Alert Service Bulletin No 33

(a) No.:	33
(b) Revision / Date	1 / 16 May 2022
(c) Title:	ALUGAS Cylinders - Temporary withdrawal from service
(d) Description:	Temporary withdrawal from service of CB2990 (Alugas) cylinders
(e) Applicability:	All hot-air balloons (from all manufacturers) fitted with CB2990 (Alugas) cylinders
(f) Effectivity:	Fuel cylinders Part Number CB2990 (Alugas) cylinders having serial numbers: OC25001 to OC25202 QI14001 to QI14494 Note: This serial number range covers all CB2990 (Alugas) cylinders currently in service. These fuel cylinders are known to be installed on, but not limited to, hot-air balloons and airships manufactured by Cameron Balloons Ltd, Colt Balloons, Lindstrand Balloons Ltd (LBL), Lindstrand Hot Air Balloons Ltd, Sky Balloons, Thunder Balloons, and Thunder & Colt

Figure 1 - Section indicating Valve Plate

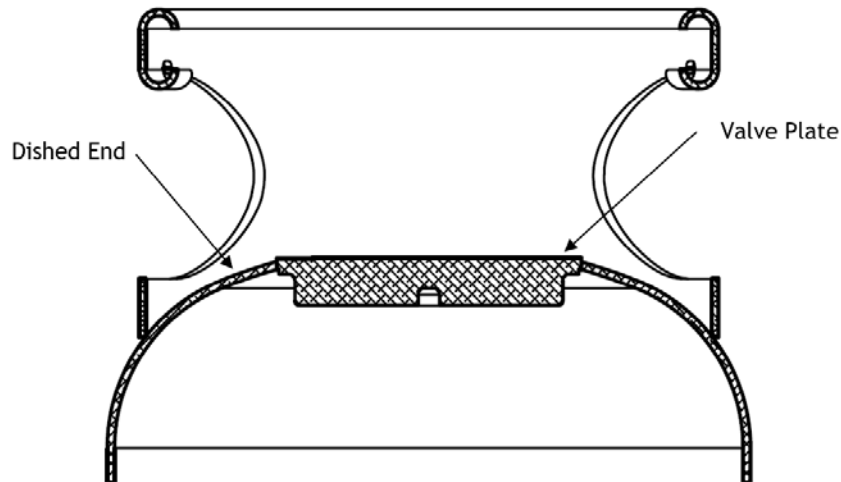
Five CB2990 (Alugas) cylinders have developed cracks in the weld between the cylinder valve plate and the upper dished end. These cracks allow the release of propane from the cylinder. Failures have been observed during periodic inspection (hydraulic pressure test), and leak test. All the in-service failures seen to date have been from the batch of cylinders with serial numbers starting OC.

Within 24 hours of receipt of this bulletin affected cylinders must be checked for leaking around the interface between the cylinder valve plate and the upper dished end using leak detector fluid. Any cylinders found to be leaking must be emptied of fuel immediately. A pilot may carry out this inspection. A satisfactory leak check **does not** release the cylinder to service.

Within 7 days of receipt of this bulletin affected cylinders must be completely emptied of fuel.
